**EMBASSY TOWER
1-13A MARSHALL AVENUE
ST. LEONARDS**

ACCESS REVIEW

21 November 2014

Figure 1: Visitable Toilet (Extract from AS4299-1995)

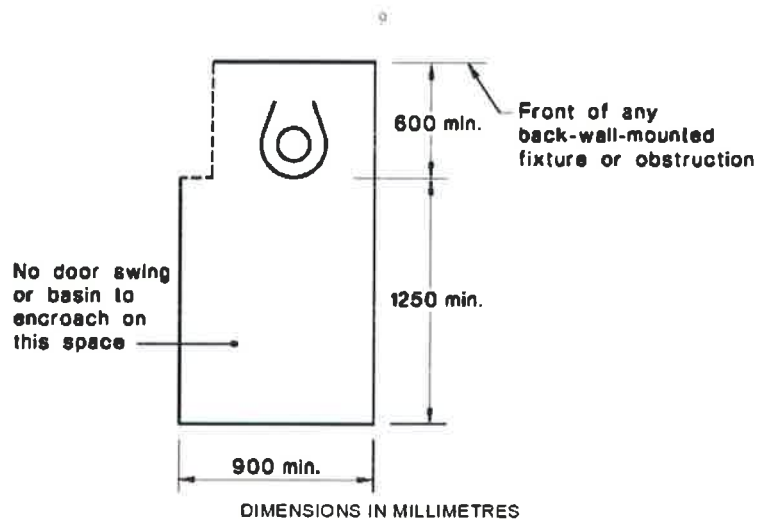
- The dimensions and layout of the specified 'visitable toilet' with a clear floor space of 900mm x 1250mm does not provide adequate circulation for a wheelchair user who prefers angled or side transfer on and off the pan.

Figure 2: Ambulant Toilet (Extract AS1428.1-2009 - Figure 53(A))

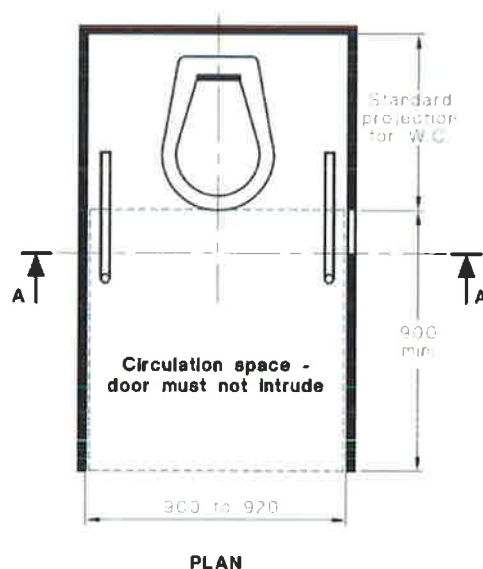
- In addition, the design of the visitable toilet is not required to be fitted with grabrails to allow a person to transfer on and off the pan.
- In line with the DCP requirements, the proposed 'ambulant' toilet (refer figure 2) will cater for families with strollers or prams for young children, older and frail aged people and persons with an ambulant disability.
